Arts Building Seismic Correction & Renewal
Project No. FM090010L/988720

Addendum No. 3

July 14, 2010

ADDENDUM NUMBER 3

**FIRST FLOOR UNIT 1
DEMO FLOOR PLAN**

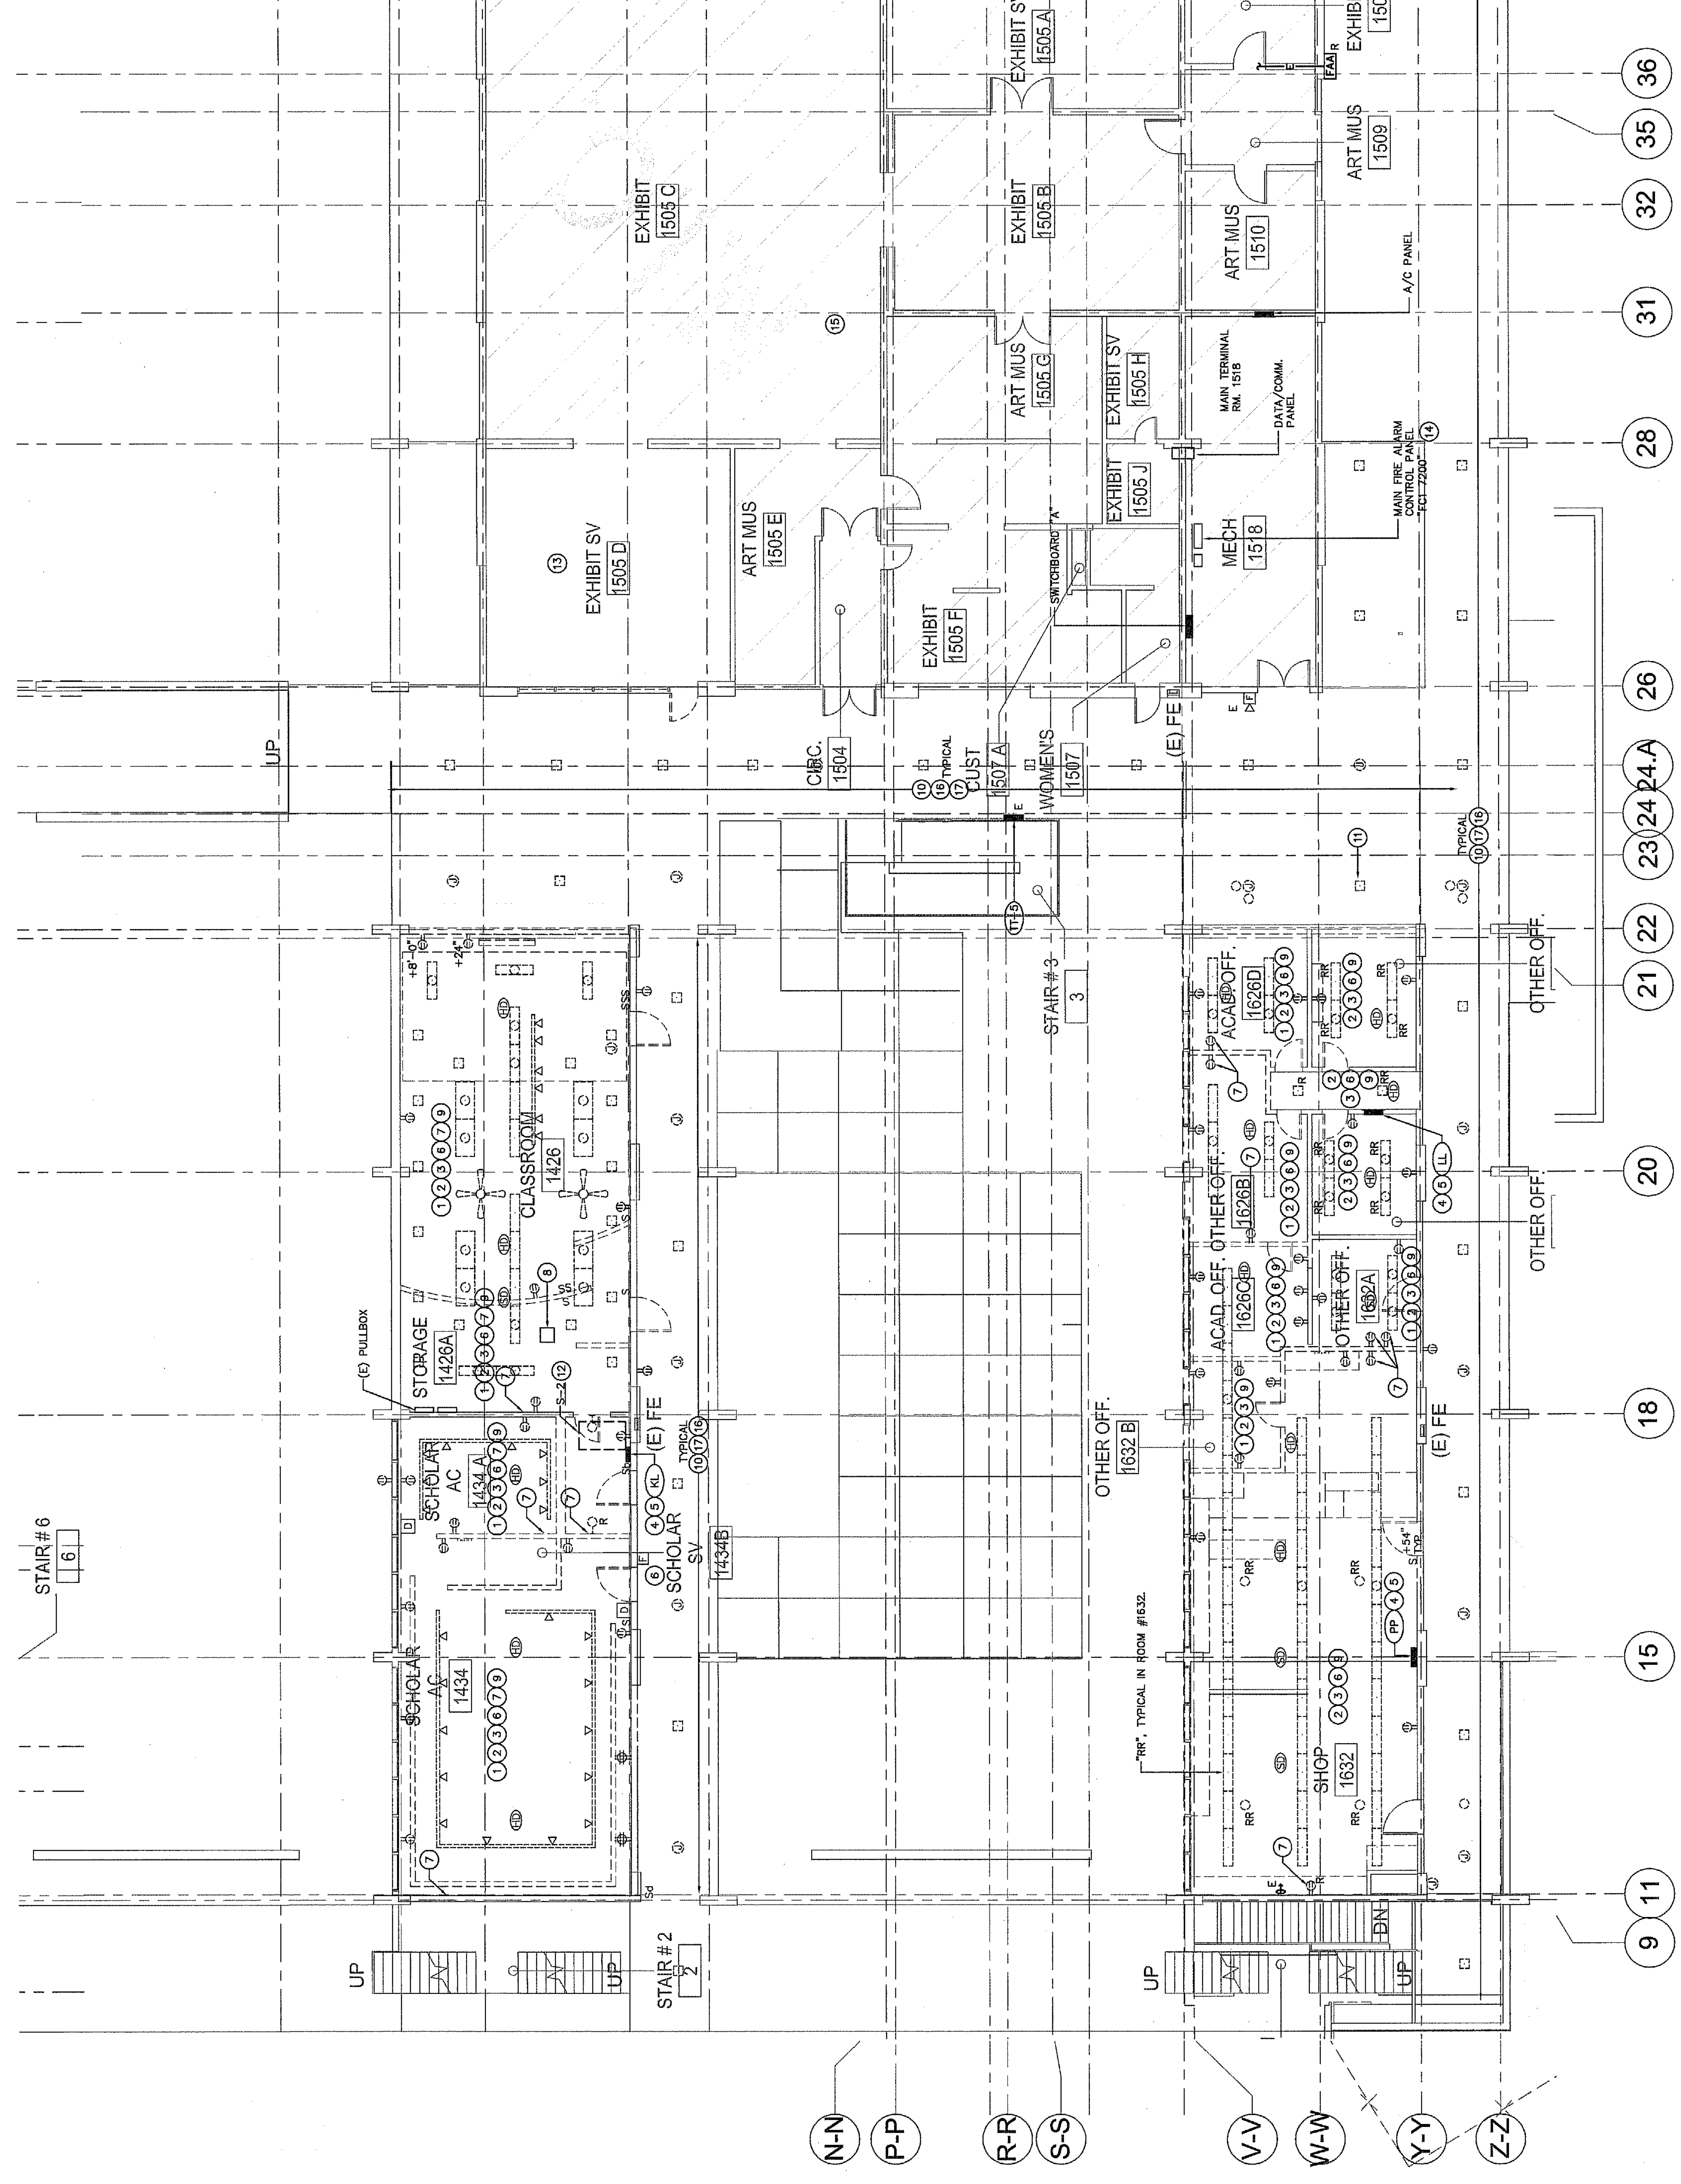
29. DRAWING NO. E1.11A, FIRST FLOOR UNIT 1 DEMO FLOOR PLAN, **Replace** in its entirety with attached drawing E1.11A, dated 7/8/2010.

E1.11B

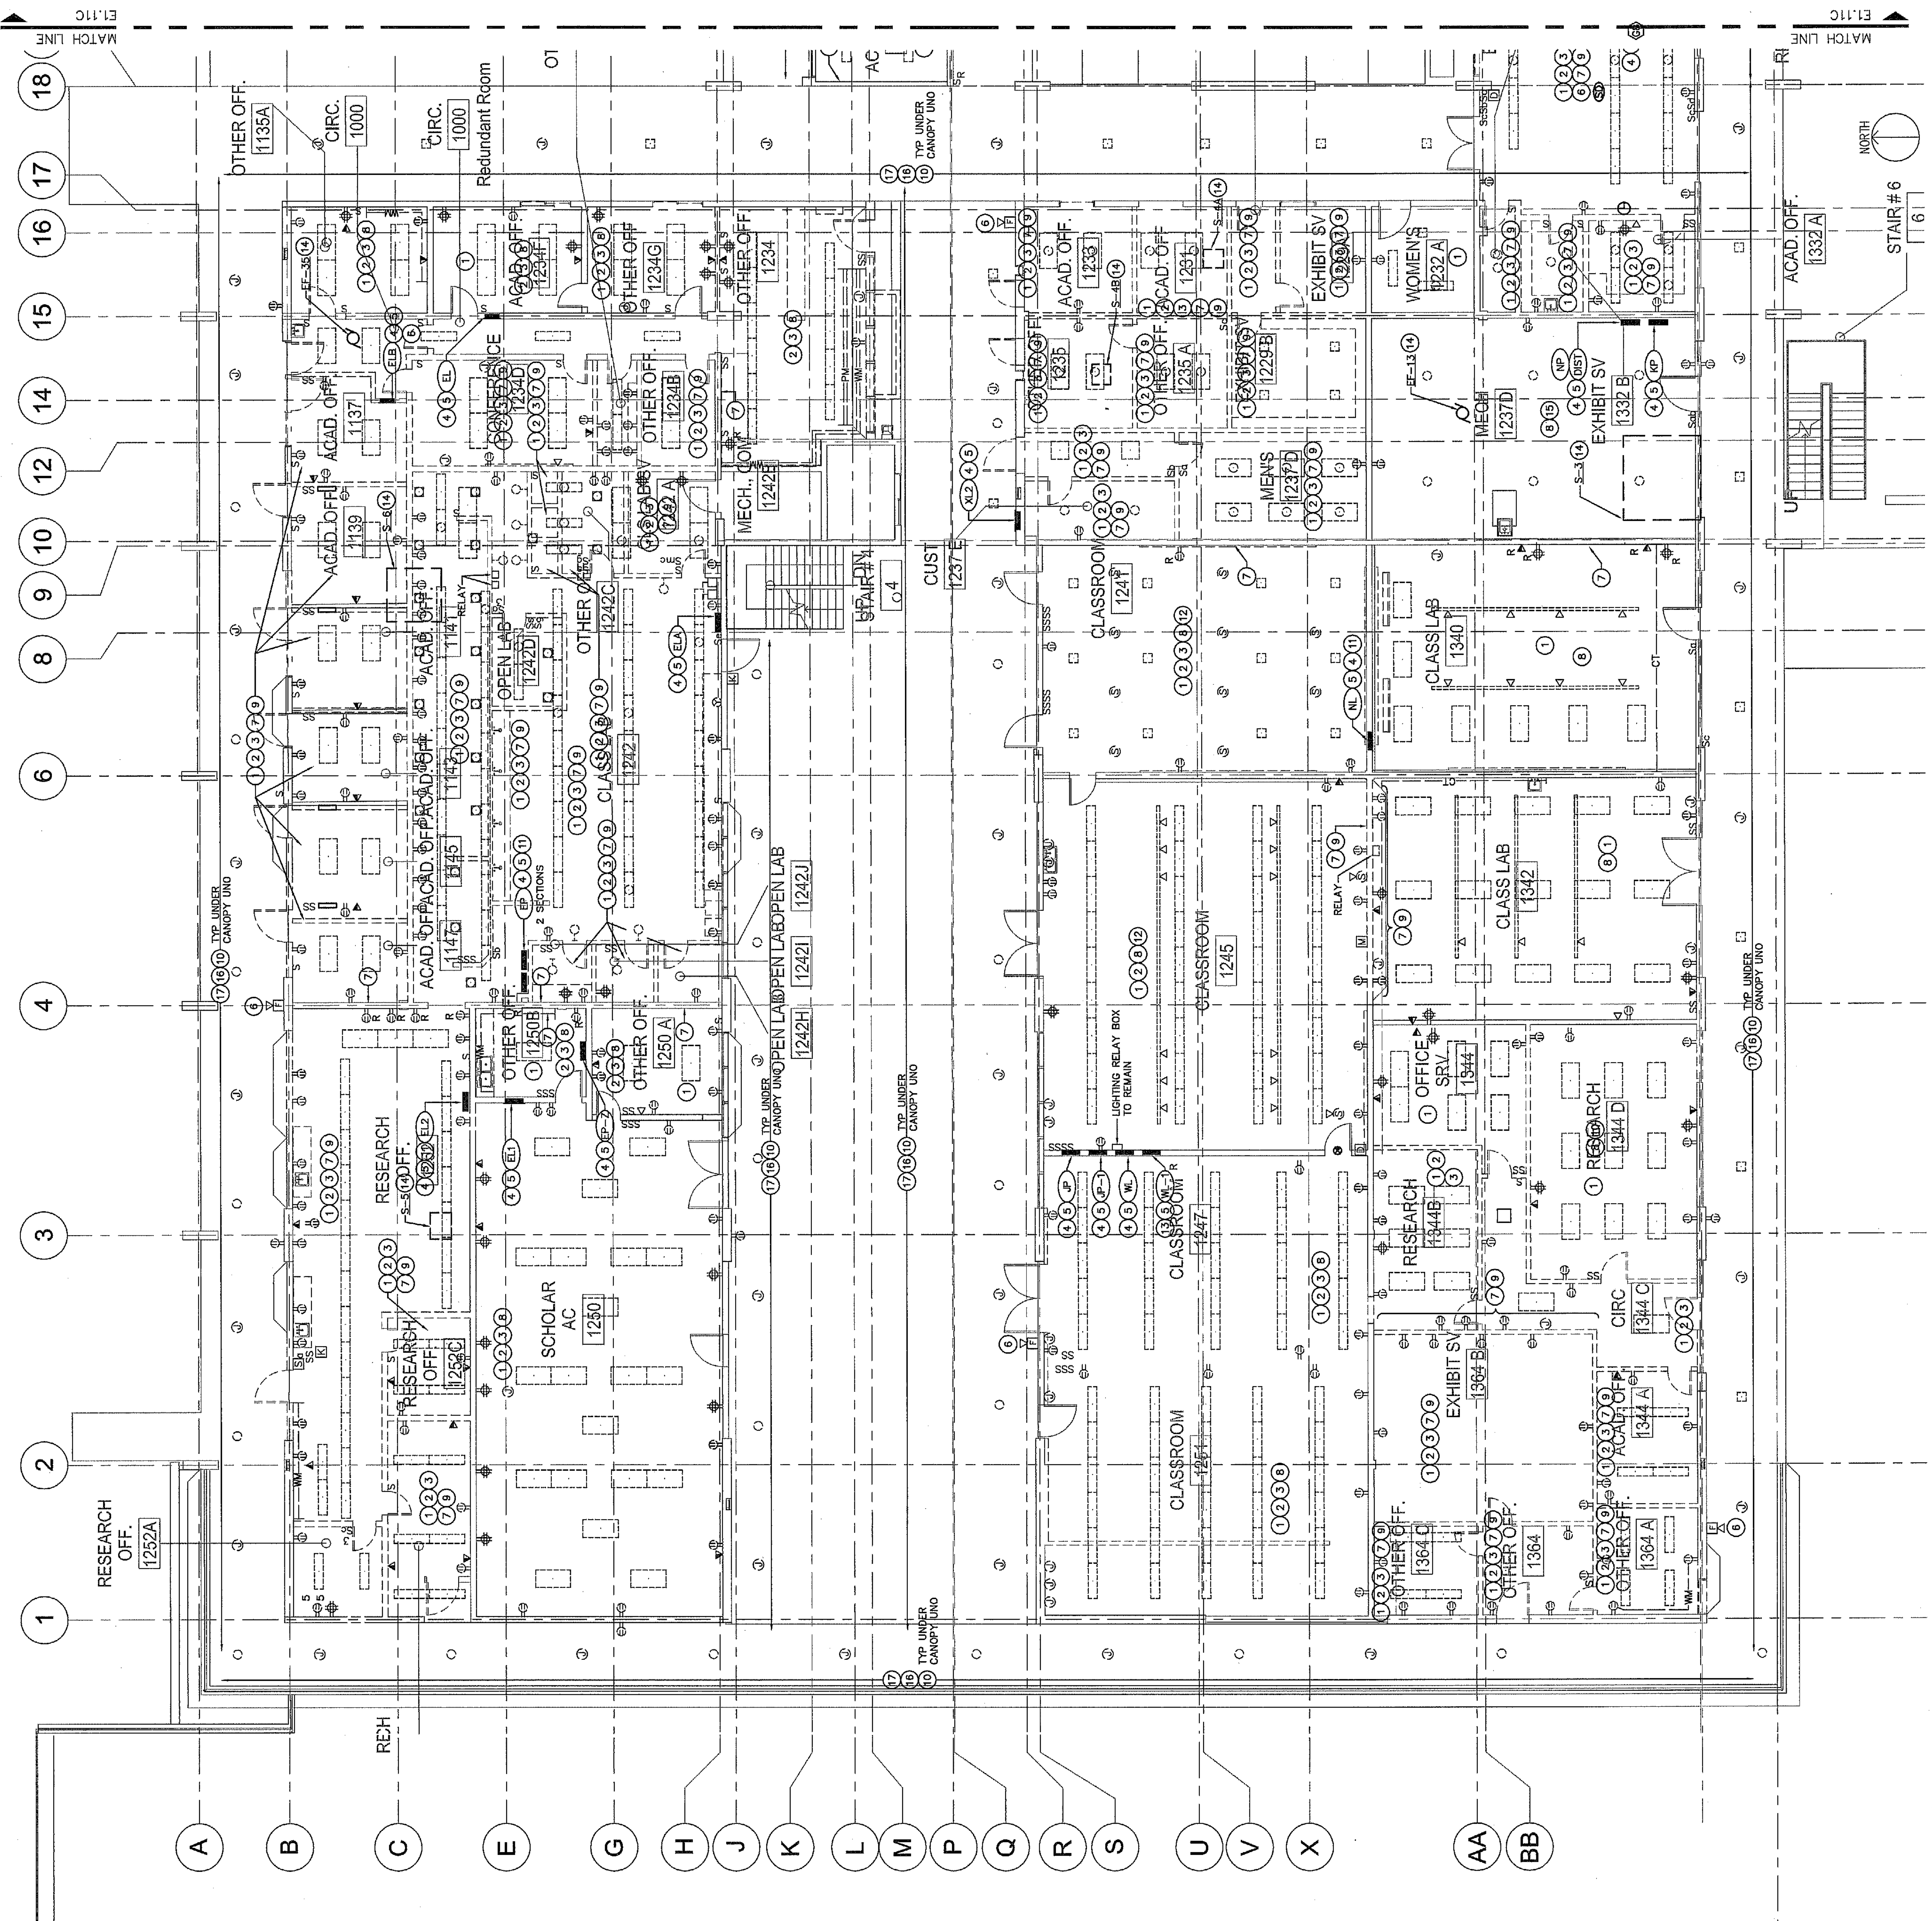
30. DRAWING NO. E1.11B, FIRST FLOOR UNIT 2 DEMO FLOOR PLAN, **Replace** in its entirety with attached drawing E1.11B, dated 7/8/2010.

E1.11C

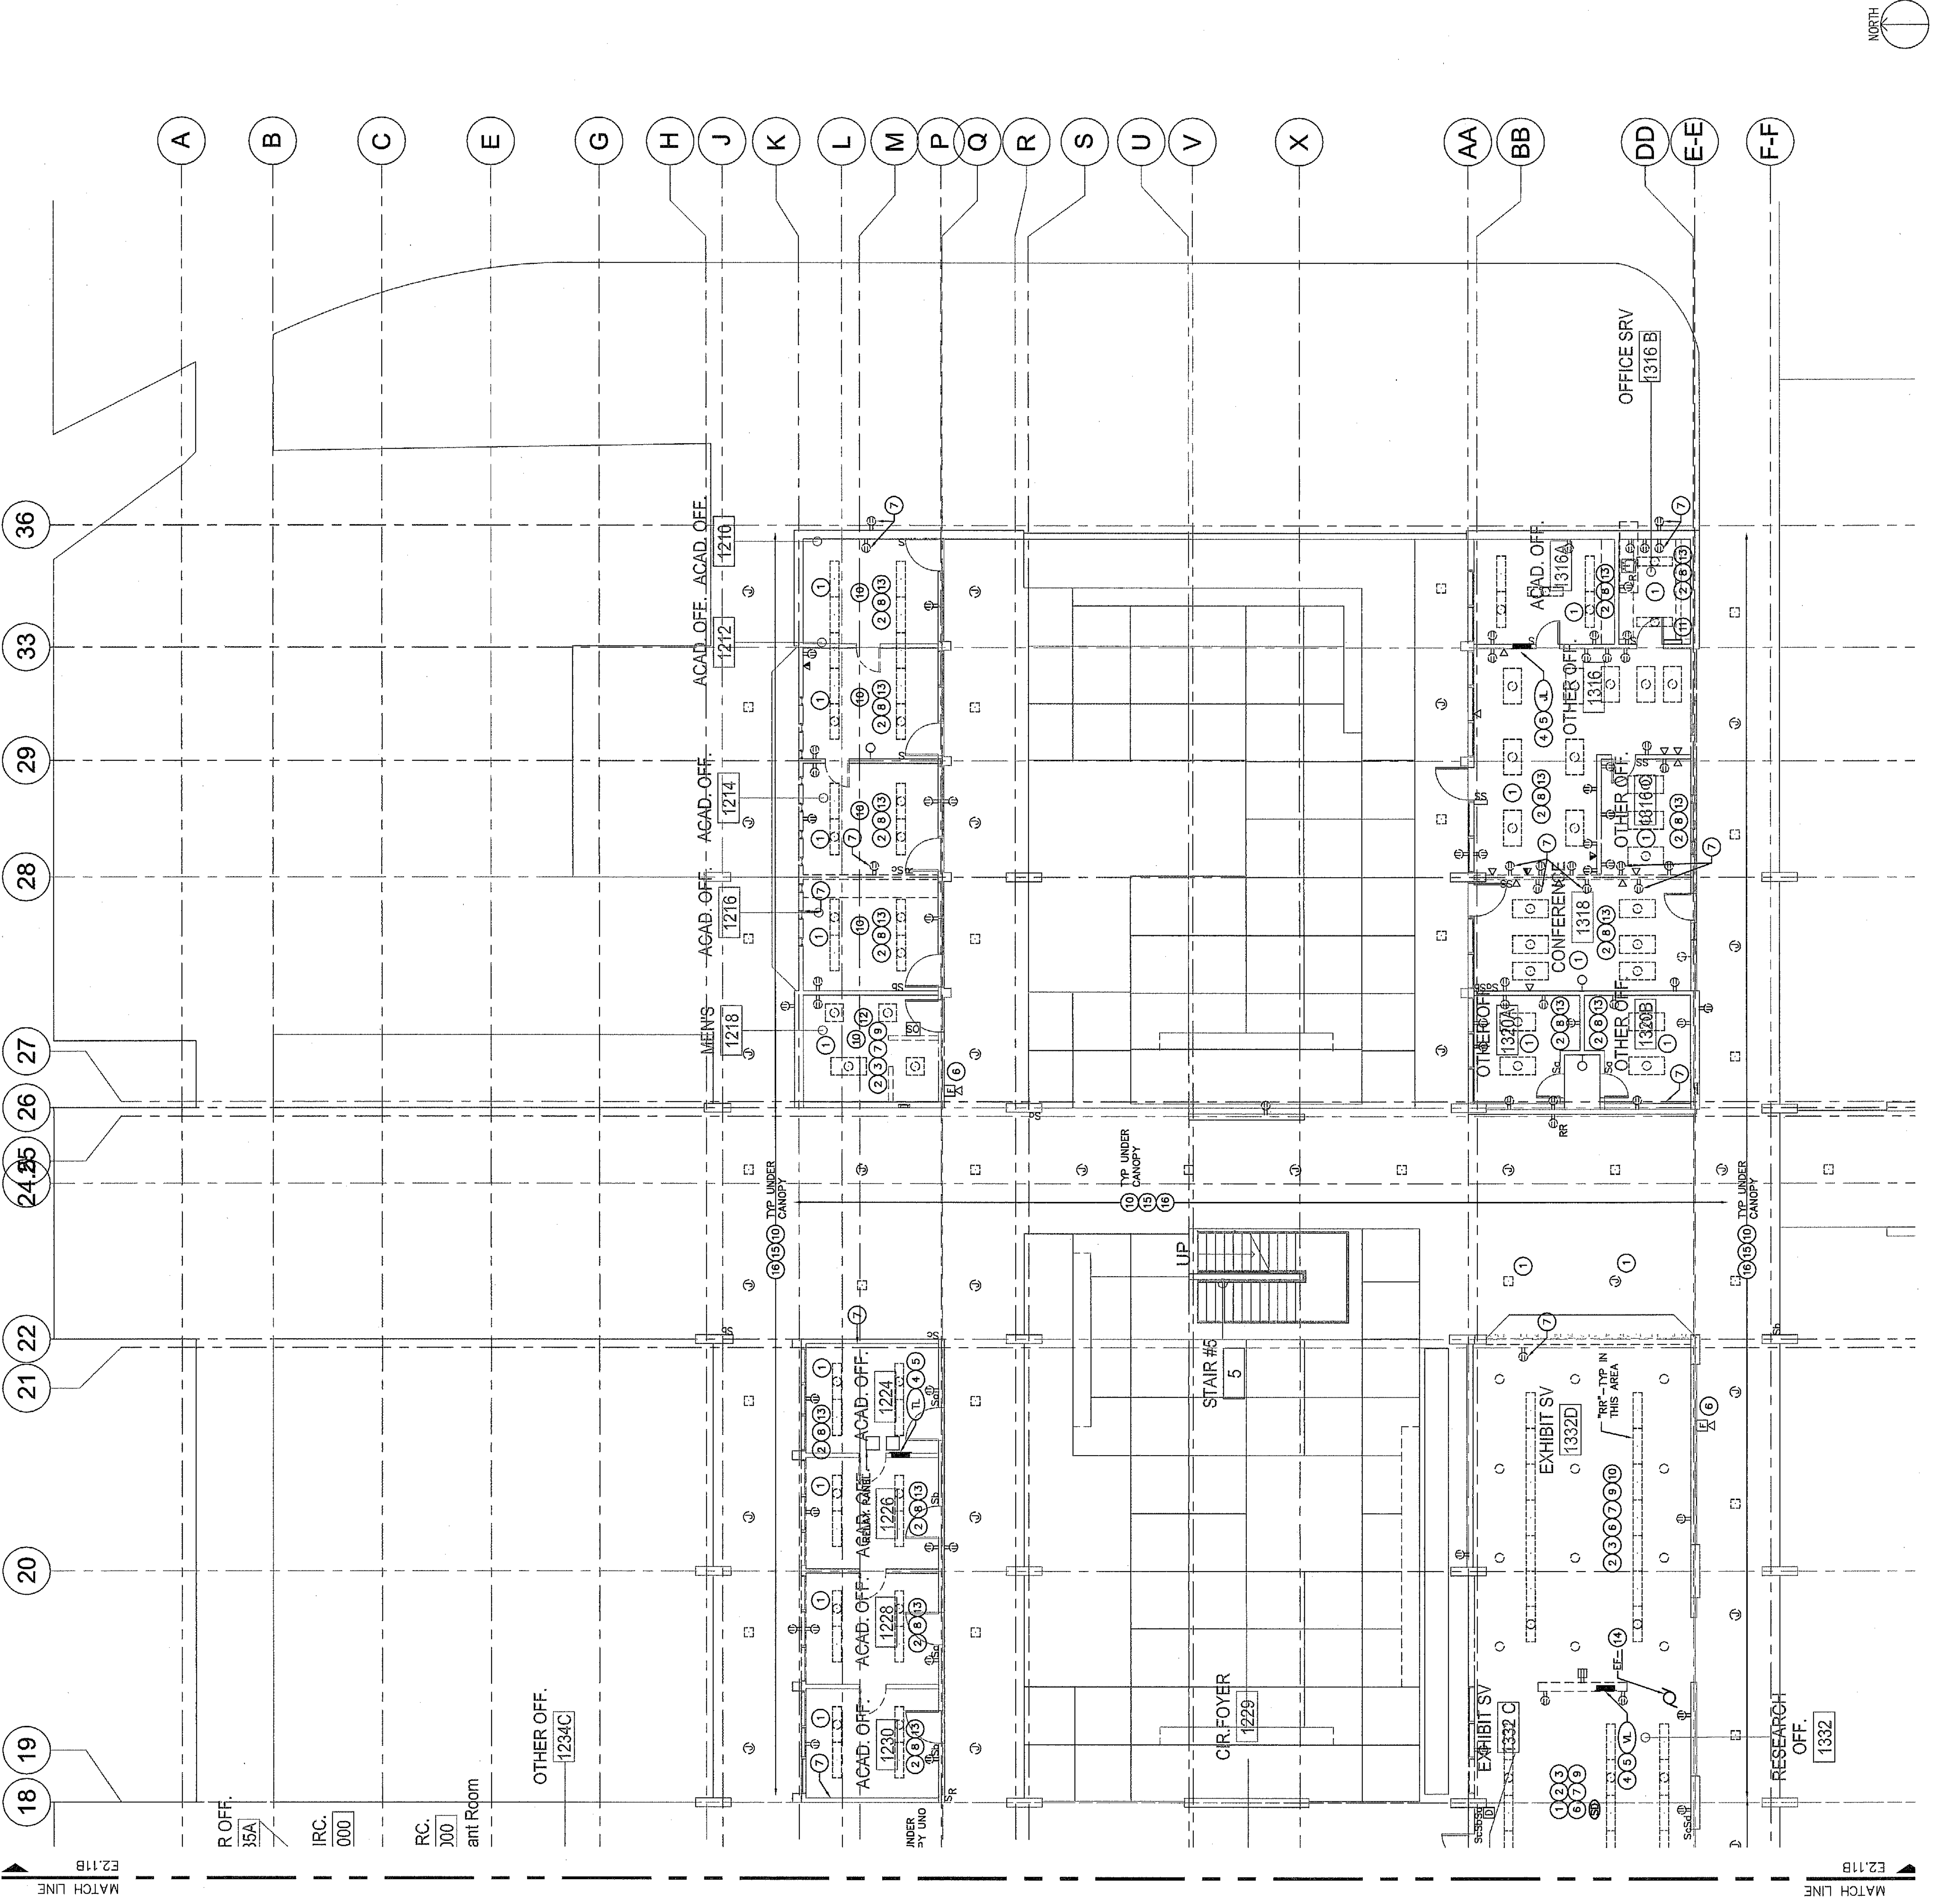
31. DRAWING NO. E1.11C, FIRST FLOOR UNIT 2 DEMO FLOOR PLAN, **Replace** in its entirety with attached drawing E1.11C, dated 7/8/2010.
